Re: Comments in response to Battle Creek Restoration Project DEIS/R

Thank you for soliciting public comments in response to the Battle Creek Salmon and Steelhead Restoration Project Draft Environmental Impact Statement/Report (DEIS/R).

ROCKY SPRINGS RANCH
Attachment # 2 - Comments to Battle Creek Restoration Project EIS/EIR

Photo # 1 - Mount Lassen Trout Farm facility adjacent to access road, Rocky Springs Ranch

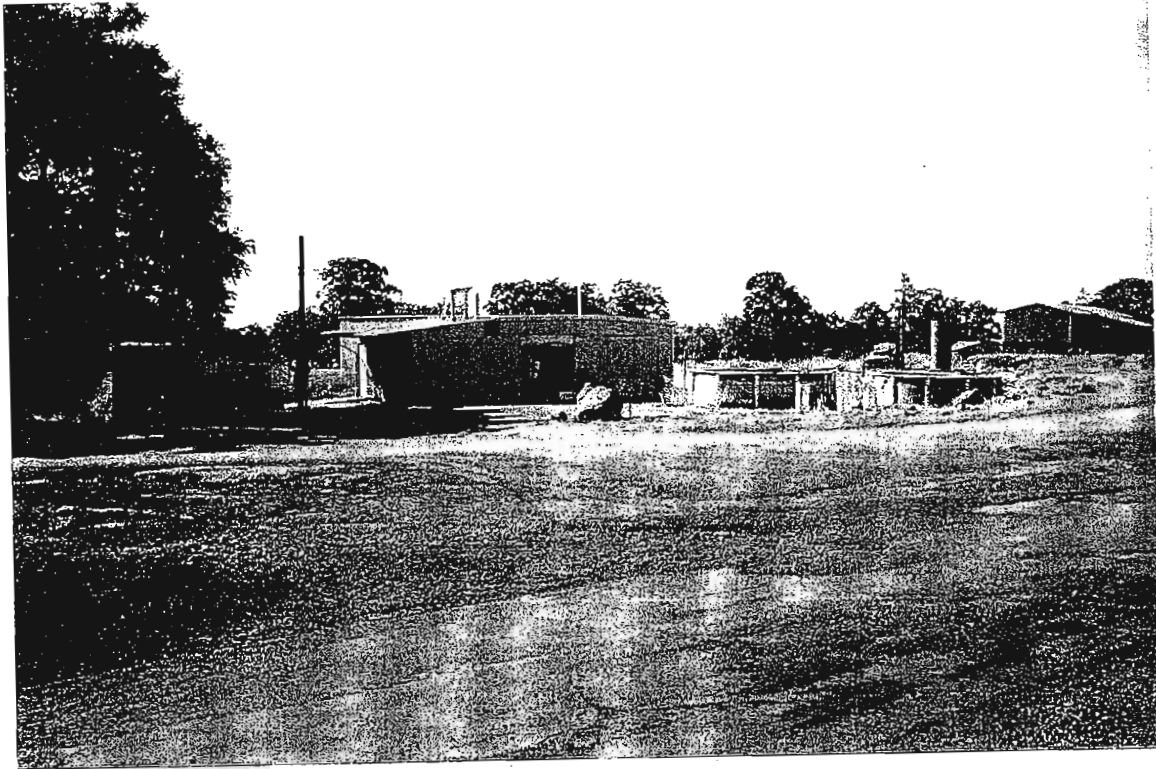
Table 4-10-4 does not include helicopters or cement batch plant operations. The Rocky Springs Ranch Residence is within 50 feet of the access road and will be greatly impacted. The Mount Lassen Trout Farm facility at Rocky Springs Ranch is adjacent to the access Road and will be heavily impacted by noise.

#6 - Location of new access road on Oasis Springs property

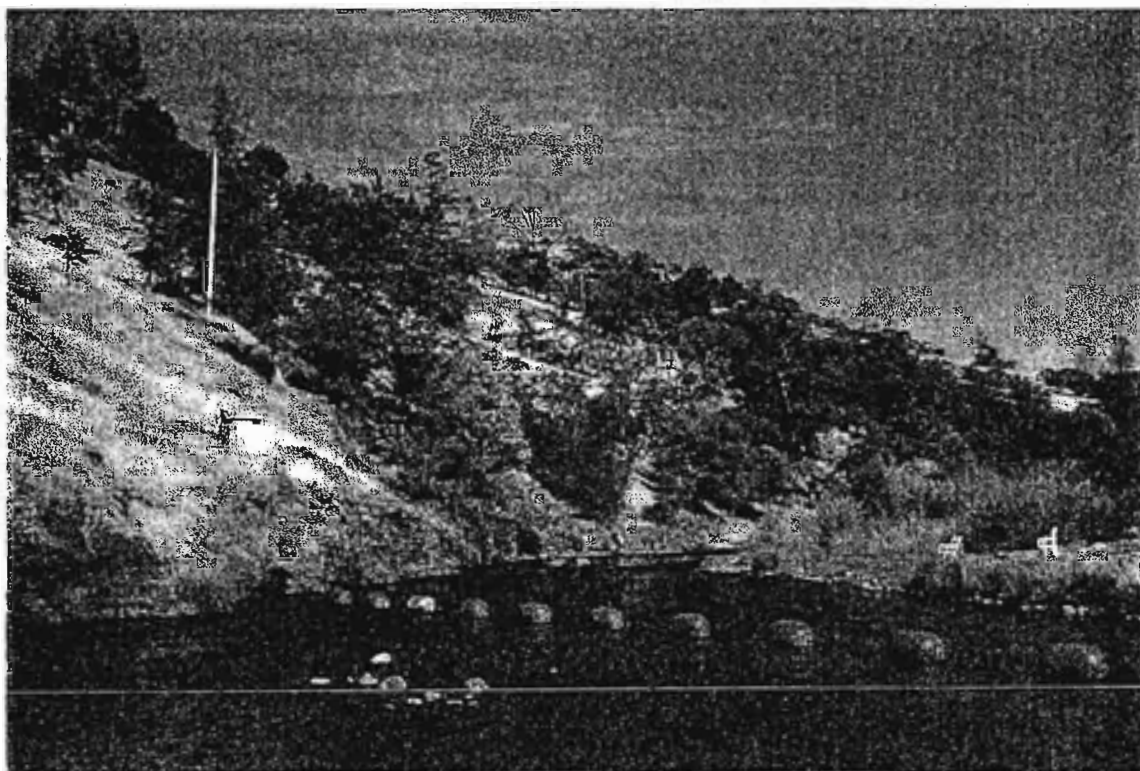
The proposed access road to Inskip will severely impact existing views from the lodge and adjacent facilities. The proposed 20 foot wide road will require significant cuts. The photos contained in the EIS/EIR (Figure 4.8-3, 4.8-5 & 4.8-6) are not representative of the actual condition of the landscape for the majority of the year. Attached are photos taken from Oasis Springs in approximately the same location earlier this month. The mock up photo (4.8-6) in the document is tinted green and the majority of the year the adjacent hillside is lightly colored dry grass. A proposed cut of 31 feet (3-48) will be a significant adverse and permanent visual impact to the Lodge property. The slope must be immediately hydromulched after cutting and maintained. Can the road width be reduced from South Powerhouse to Inskip portion, thereby reducing grading and visual impacts? What alternatives have been considered and/or are available?

#3

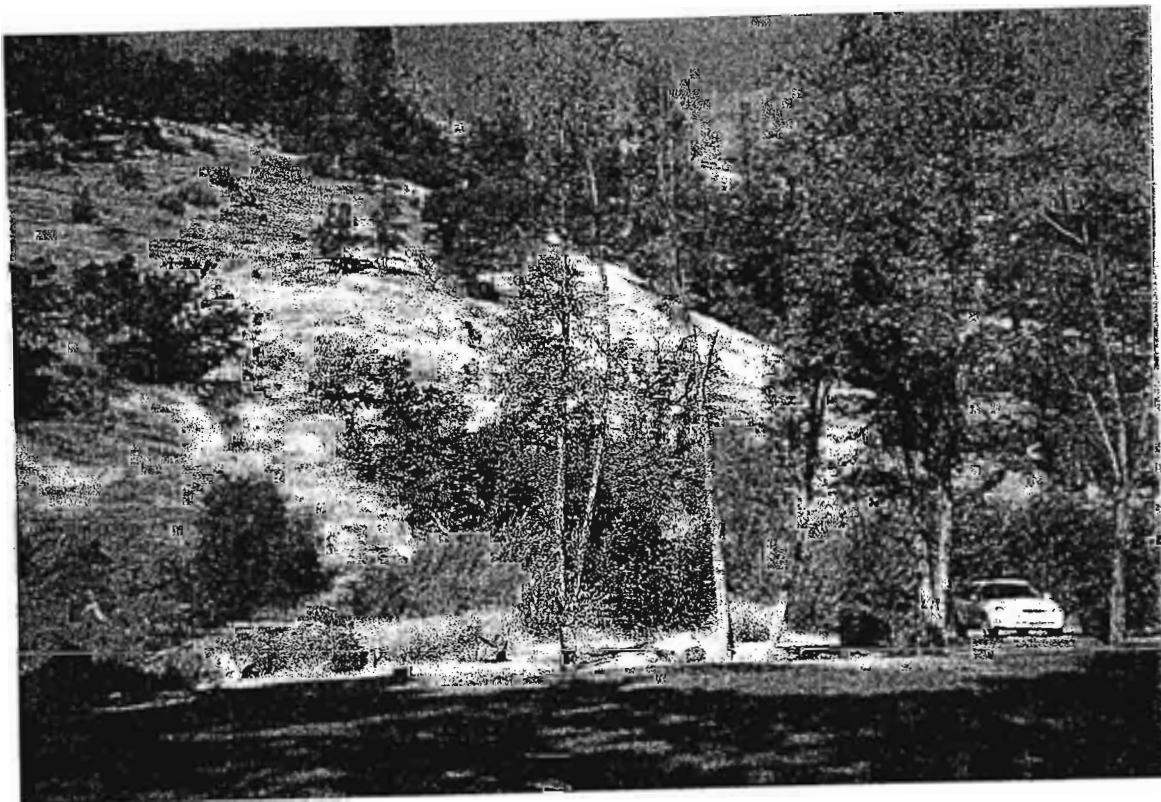
#1 - Approximately same location as Figure 4.8-5 & 6
note the light grass color, not green as depicted in mock up

#5

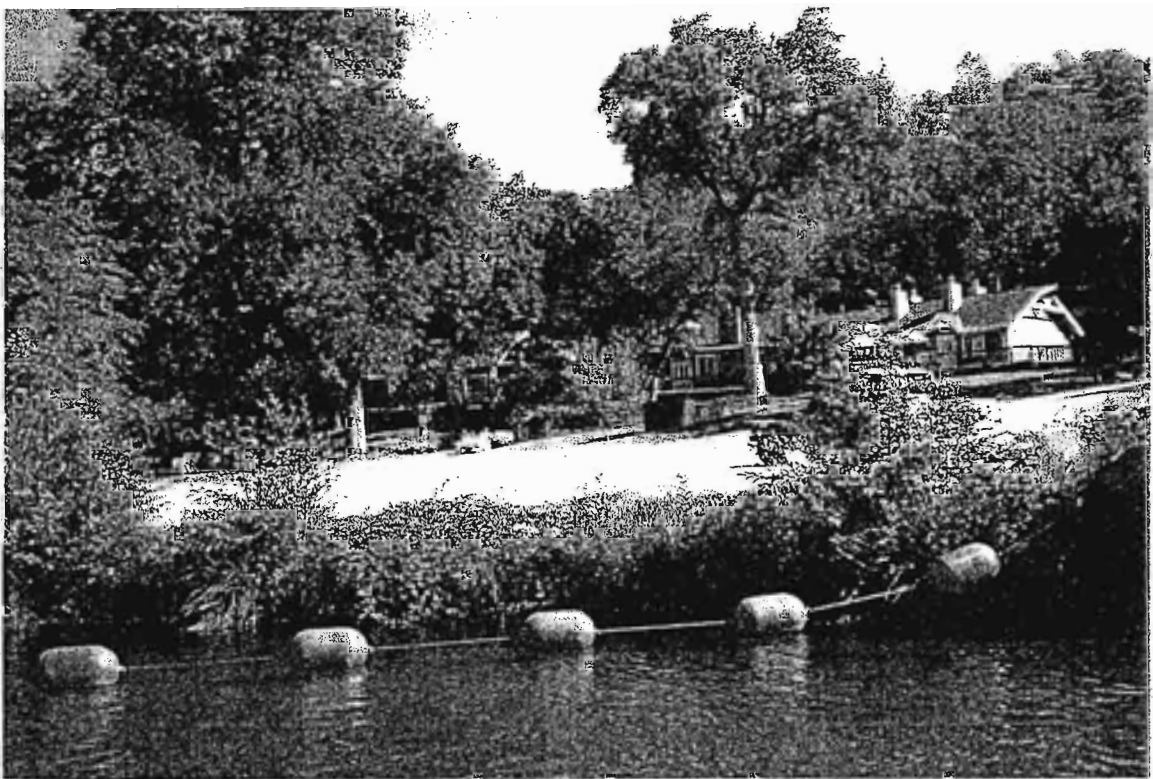
#4 - Road cut will be fully visible from Oasis Springs property

#5 - Road cut will be fully visible from Oasis Springs property
